ITS CORPORATION				REV	ECN	DATE	APV
THIS PRINT IS THE PROPERTY OF ITS CORP. IT SHALL NOT BE COPIED WITHOUT PERMISSION.				TITLE BLOCK DIAGRAM - UHF AMPLIFIER (1281-1100)			
MATERIAL				DWN	TMY	7/9/96	DWG. NO.
---				CHK	RE	7/10/96	1281-3100
FINISH				REL	RE	7/11/96	2
---				SCALE:--- SHEET 1 OF 1

ITS CORPORATION				REV	ECN	DATE	APV
REV	ECN	DATE	APV	THIS PRINT IS THE PROPERTY OF ITS CORP. IT SHALL NOT BE COPIED WITHOUT PERMISSION.			
				TITLE <i>SCH, UHF COUPLER ASSEMBLY (1227-1316)</i>			
REV	ECN	DATE	APV	MATERIAL			REV
				DWN <i>SJM</i> 2/16/94 CHK <i>DWB</i> 4-11-94 REL <i>DWB</i> 4-11-94			0
FINISH				DWG. NO.		SHEET 1 OF 1	
1227-3316				A		SCALE ---

ADC Telecommunications				A0		20028104		5/17/99		LRT			
								REV		ECO		DATE		APV			
APV		THIS PRINT IS THE PROPERTY OF ADC, IT SHALL NOT BE COPIED WITHOUT PERMISSION.				TITLE SCH, SINGLE STAGE AMPLIFIER ASSY., CLASS A, MID BAND (1265-1416)											
DATE		MATERIAL -----															
ECO		FINISH -----				DWN		GK		1/29/96		DWG. NO. 1265-3416				REV B0	
REV						REL		JAG		3/19/96		C		SCALE ---		SHEET 1 OF 1

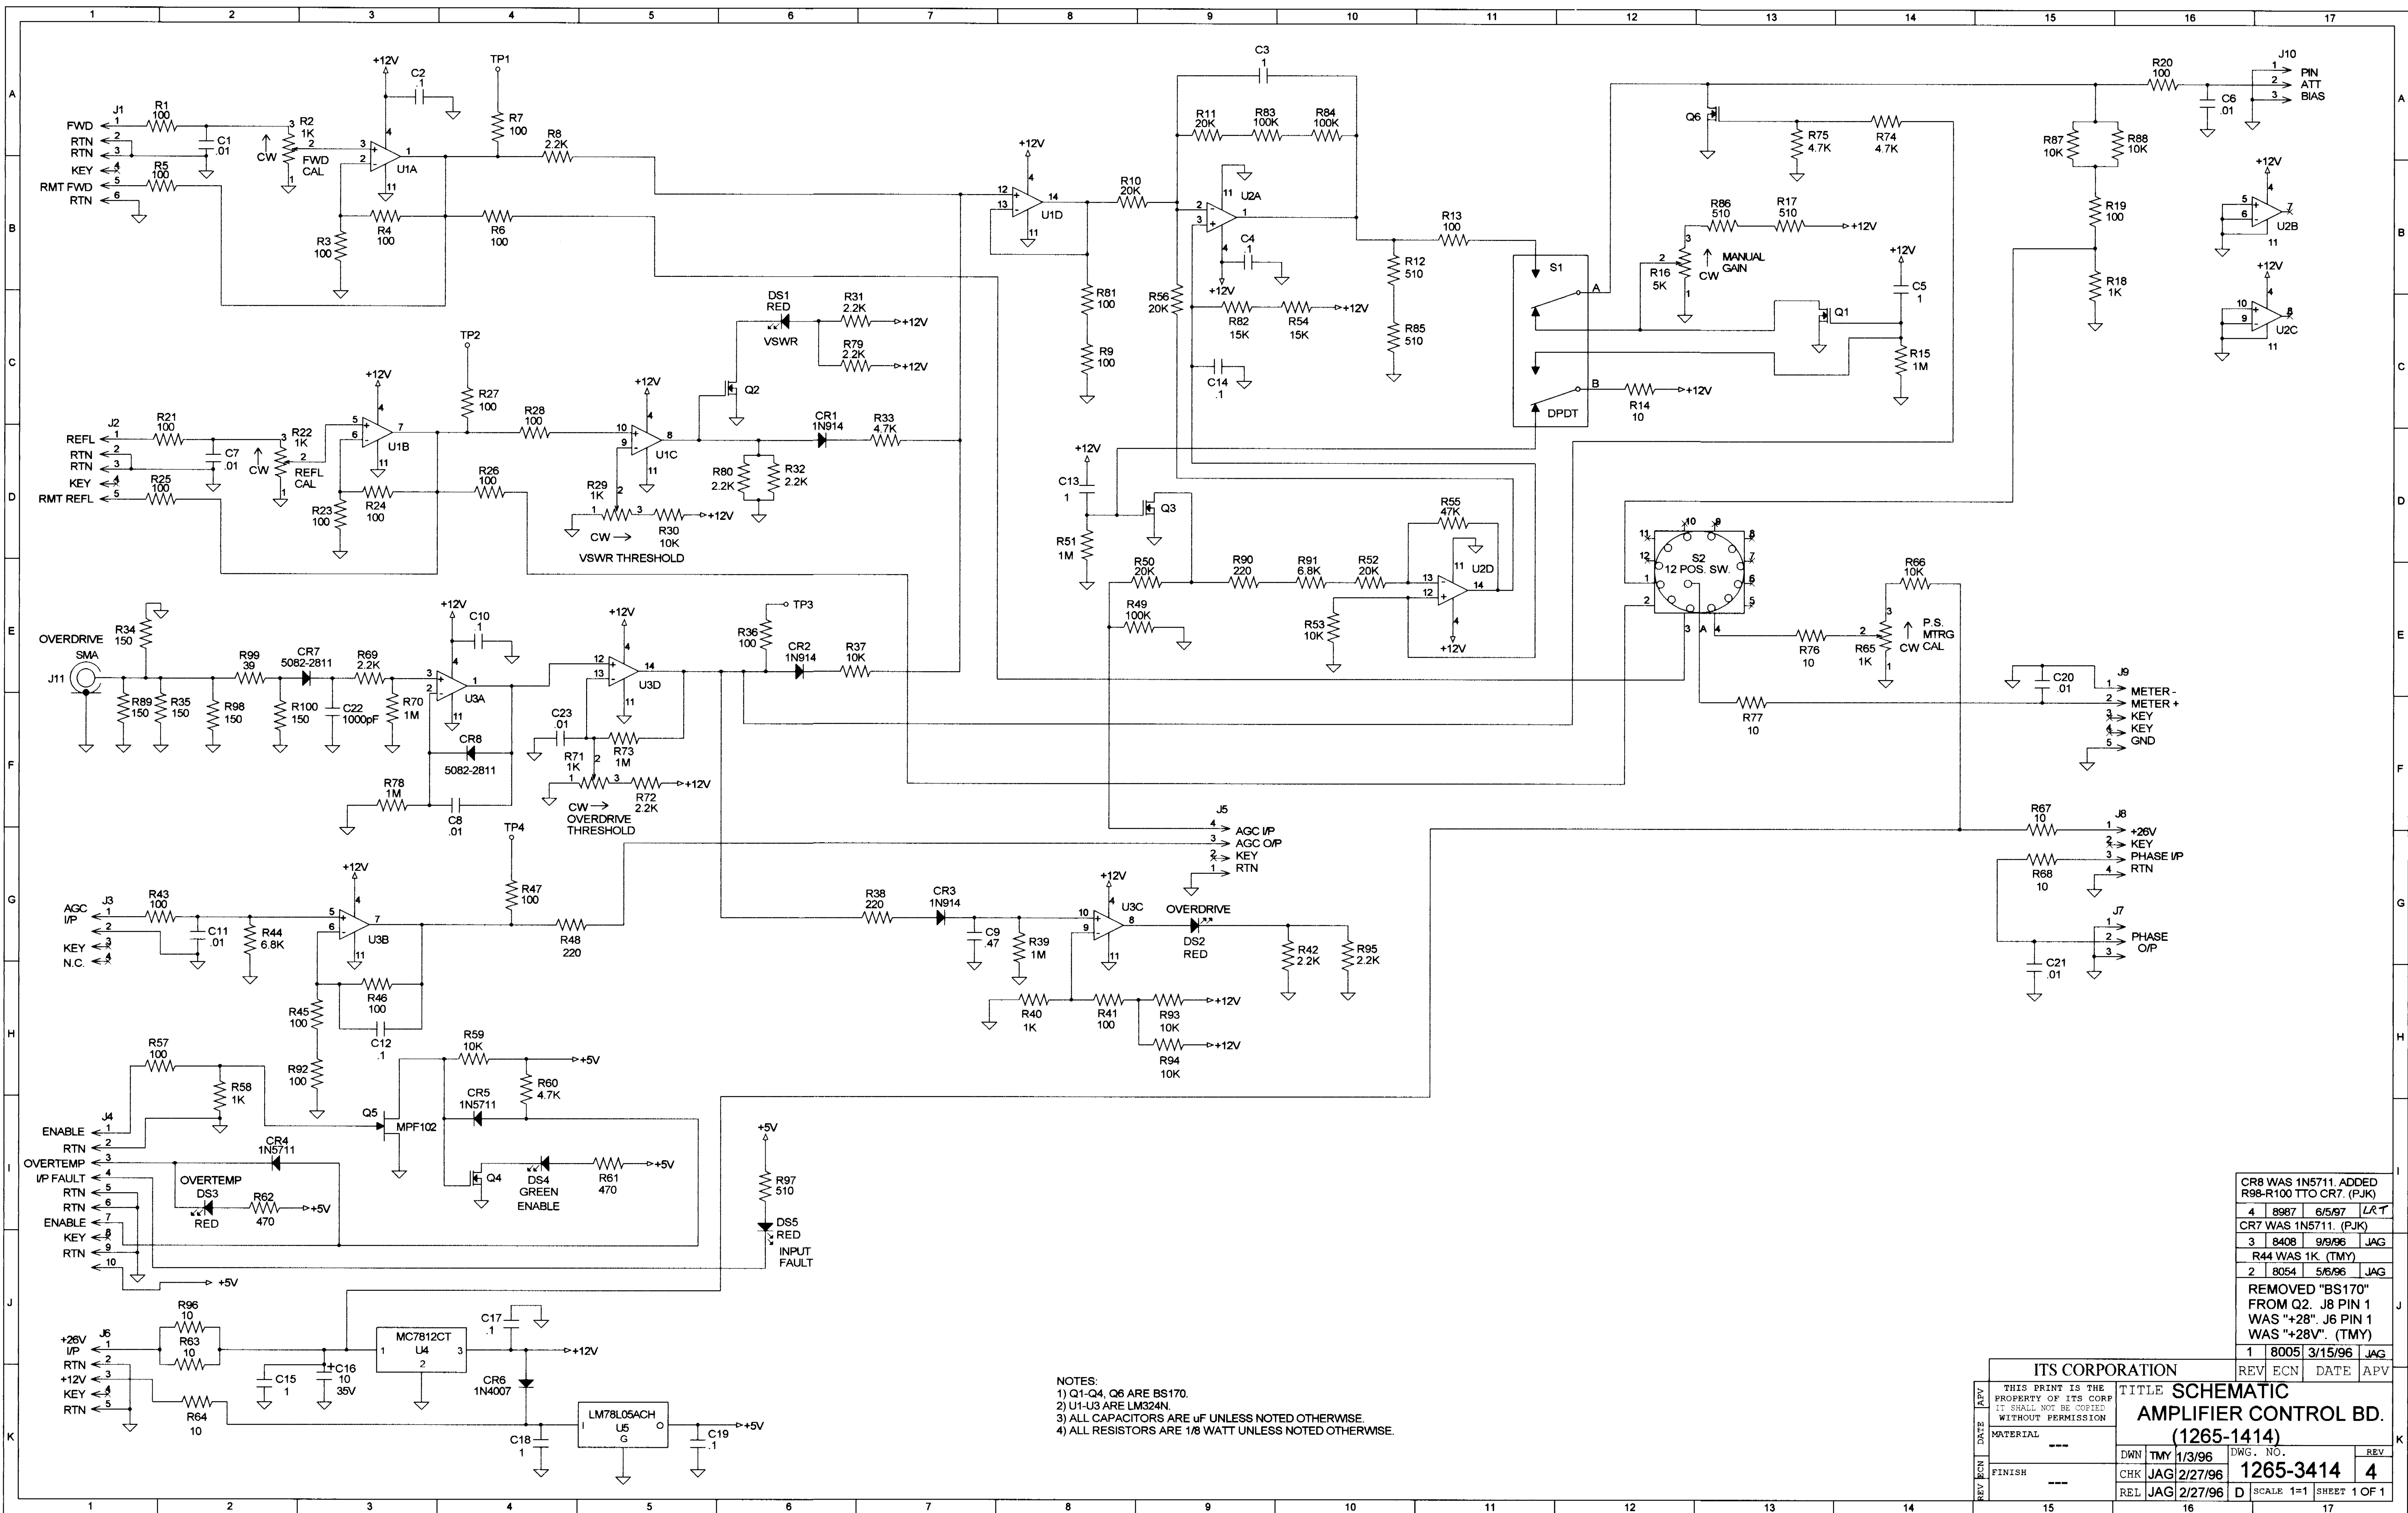
CHANGED C19 FROM 20pF TO 10pF. ADDED C32 10pF TO THE RIGHT OF C19. (MMM)
B0 20054250 6/21/00 LRT
DELETED C3 AND C4. CHANGED C5 FROM .8-10 pF TO 120pF. CONN. C5 TO C6. CHANGED C6 FROM 8.2pF TO 20pF. CHANGED C19 FROM .8-10 pF TO 20pF. CHANGED C22 FROM 20pF TO 8.2pF. ADDED C23 8.2pF TO RIGHT OF C22. CHANGED C23 TO C3, .8-10pF.(MAS)

ADC Telecommunications		A0	20028104	5/17/99	LRT
		REV	ECO	DATE	APV
APV	TITLE SCH, SINGLE STAG AMPLIFIER ASSY, CLASS A, LOW BAND (1265-1418)				
DATE					
REV	MATERIAL		DWN	GK	1/29/96
ECO	FINISH		CHK	JAG	3/19/96
REV			REL	JAG	3/20/96
		DWG. NO. 1265-3418		REV A0	
		SCALE ---		SHEET 1 OF 1

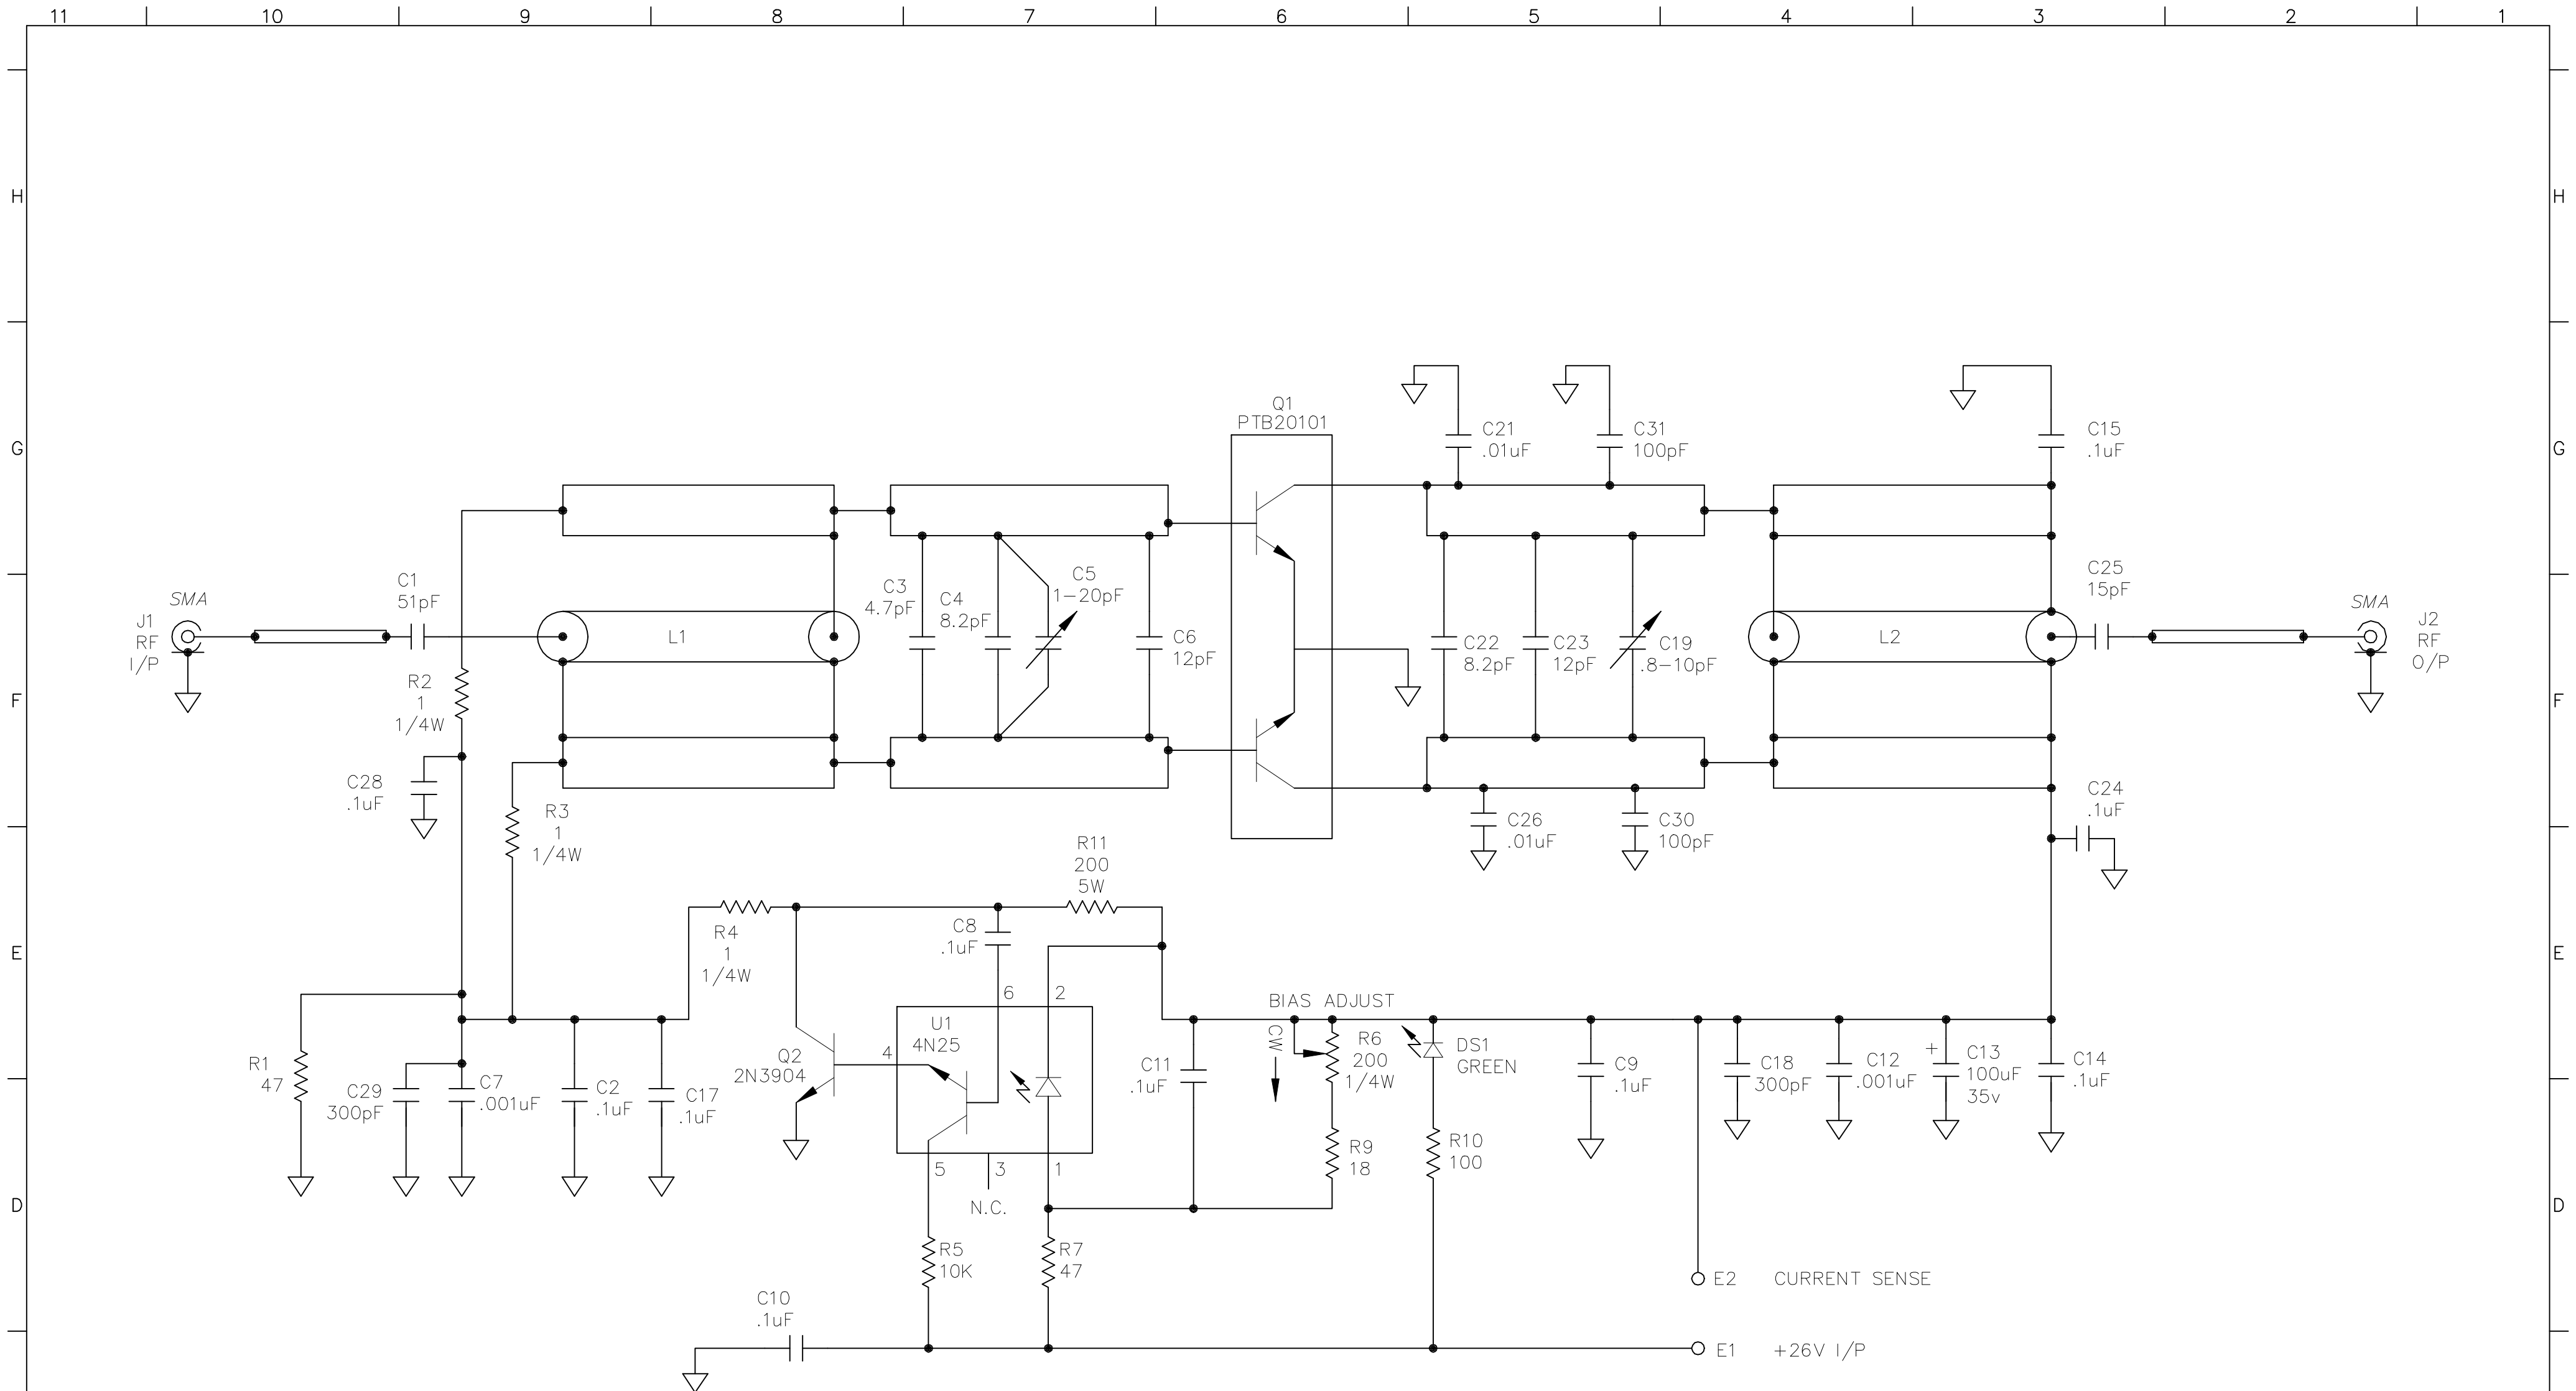
CHANGED C3 FROM 13pF TO 4.7pF, C4 FROM 4.7pF TO 8.2pF, C5 FROM .8-10 pF TO 1-20pF, C6 FROM 20pF TO 12pF, C22 FROM 13pF TO 8.2pF. MOVED C19 TO THE RIGHT OF C23. (MAS)
